Subject: Response to Nevada Division of Environmental Protection (NDEP) Comments to the Revised Work Plan to Evaluate Effective Groundwater Capture at Tronox LLC, Henderson, Nevada

**Tronox response to October 3, 2007 NDEP comments on
Capture Work Plan dated August 29, 2007**

**PROPOSED WELLS AT
THE INTERCEPTOR WELL FIELD**
Capture Zone Work Plan
Tronox Facility
Henderson, Nevada

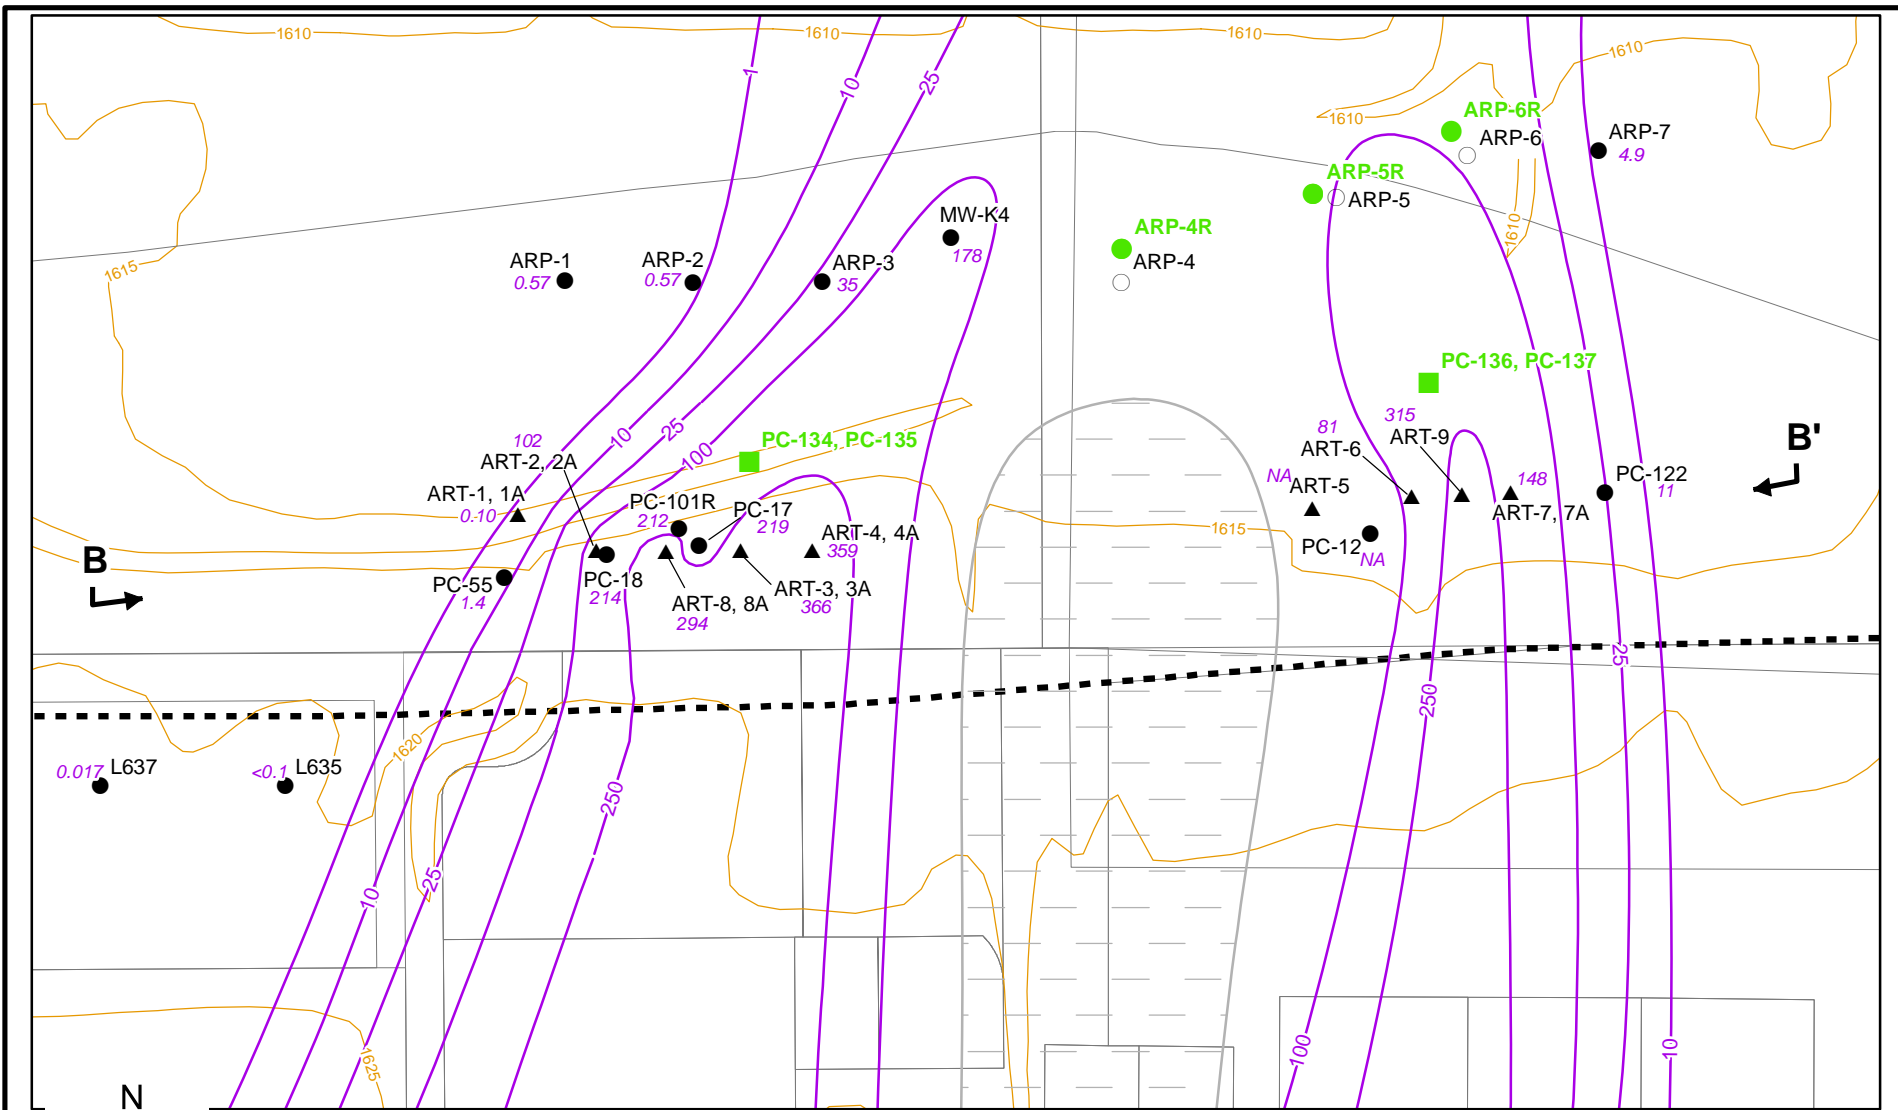
3. General comment, please discuss if any hydraulic testing will be conducted in the wells that are proposed to be installed (e.g.: slug testing or pump testing) **at the meeting referenced in the cover letter**.

The locations of these wells are shown on the revised figures attached to this document. Please note the change in the nomenclature and the reference to the prior well identification in parentheses.

Tronox provided draft cross sections for the November 14, 2007 conference call with NDEP. These sections have been revised showing the corrected nomenclature for the well identification and are provided as Figures 6, 7 and 8 (attached). In addition, the plan-view maps provided in the work plan have also been revised to reflect the corrected nomenclature and are also attached.

WEST - EAST HYDROGEOLOGIC CROSS SECTION A-A'
INTERCEPTOR WELL FIELD
 Proposed Monitoring Wells
 Capture Zone Workplan
 Tronox Facility, Henderson, Nevada
 SCALE: as noted
 DATE: 7/19/2007
 PROJECT NUMBER: 04020-023-160
 Rev: 11/27/07

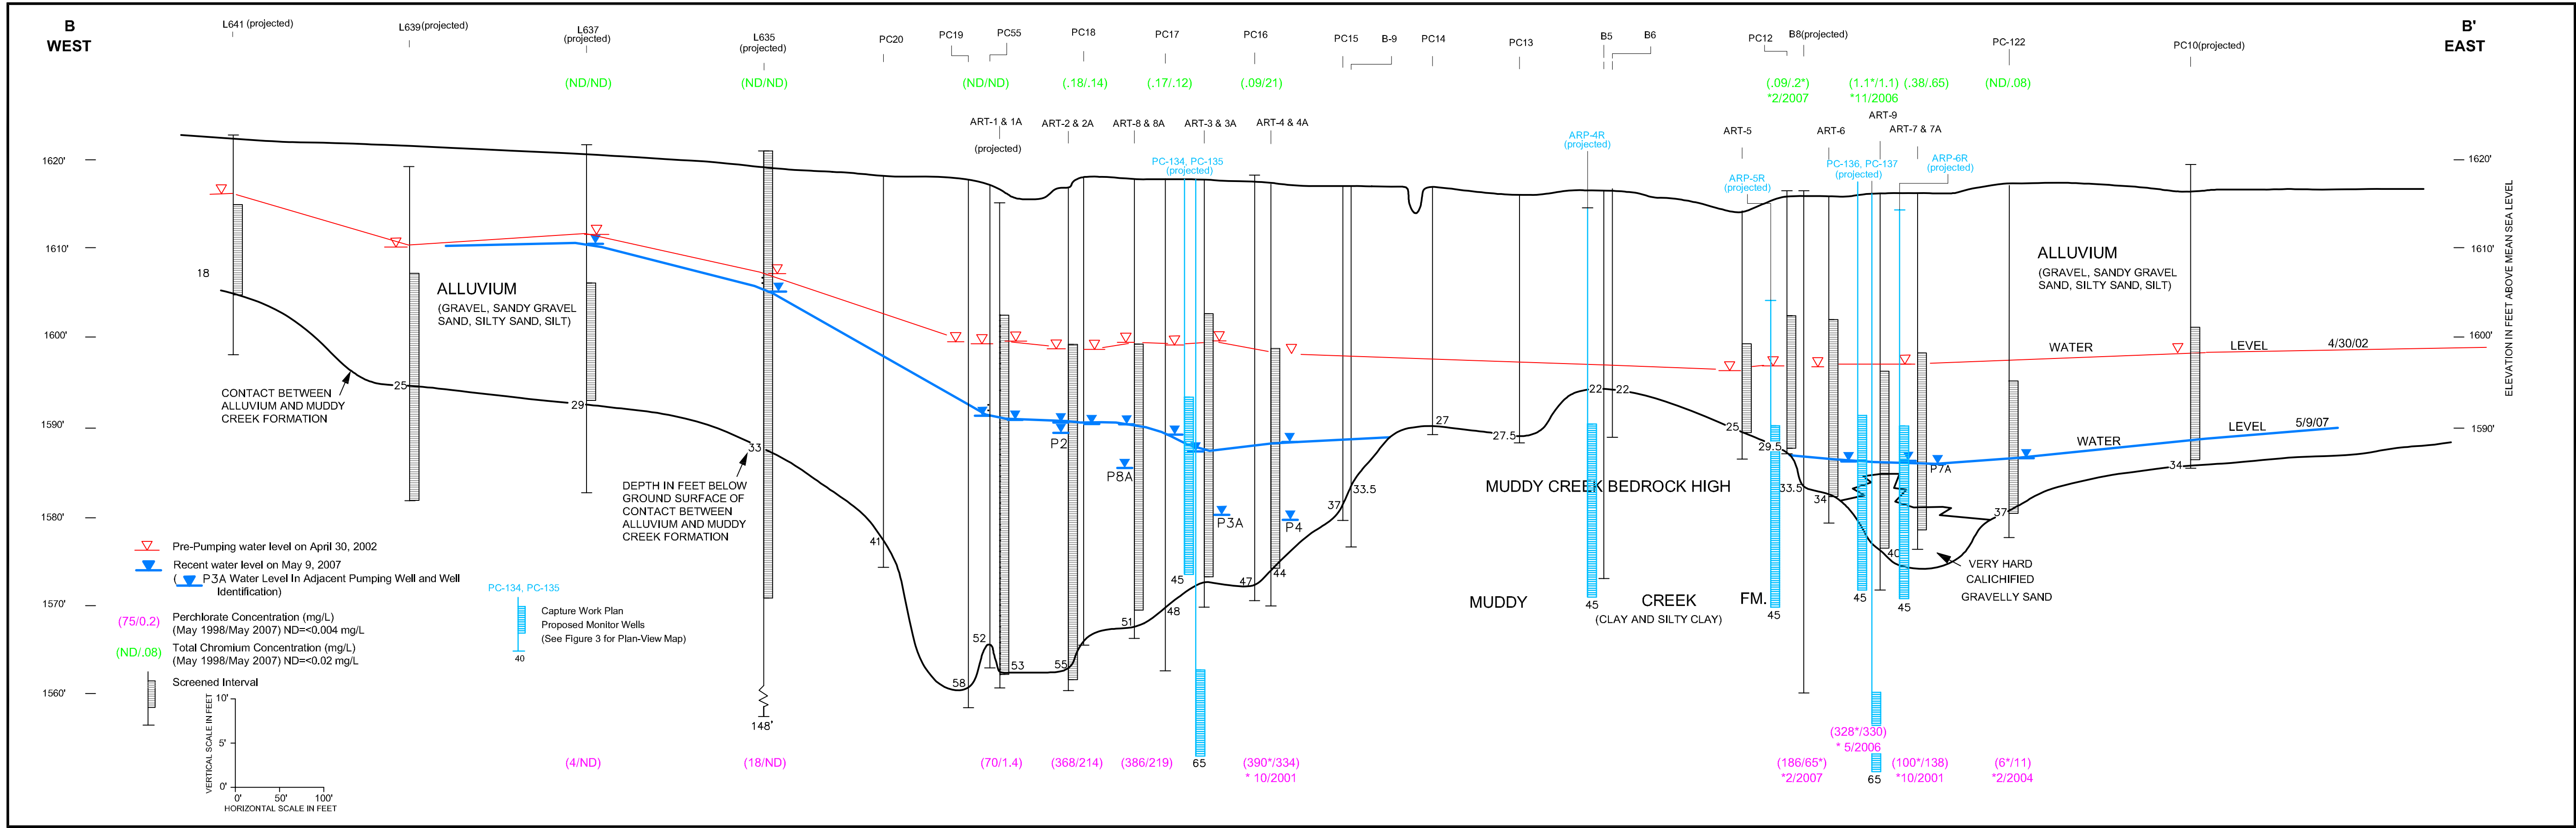
- b. TRX states that the “Groundwater in the Muddy Creek, subsequently “dammed up” behind the groundwater barrier wall...” Please provide a cross-section of the Interceptor Well Field including the as-built dimensions of the barrier wall for a comparison of well depths versus the depth of the barrier wall and the depths of the geologic units.

9. Table 1, the NDEP requests that TRX prepare and submit cross-sections which present the proposed locations and depths of the new wells relative to existing wells, geologic units and saturated thicknesses. Please provide this at the meeting referenced in the cover letter.

- b. *Figure 2 of the Annual Remedial Performance Report for Chromium and Perchlorate, Tronox LLC, Henderson, Nevada, July 2006 – June 2007 is a cross section of the Interceptor well field and includes the dimensions of the barrier wall for a comparison of well depths versus the depth of the barrier wall and the depths of the geologic units. This figure was also provided for the conference call on November 14, 2007 and is attached as Figure 6 to this document.*

- c. *As discussed during the conference call of November 14, 2007, vertical gradients and hydraulic conductivity will be evaluated through the installation of nested wells M-133, M-134, M-135, M-136, PC-134, PC-135, PC-136 and PC-137, which will be installed at various depths within the Muddy Creek Formation. The approximate depth and completion of the*

proposed wells that will be installed as part of the Capture Zone evaluation are shown on the attached hydrogeologic cross sections (see Figures 6, 7 and 8).
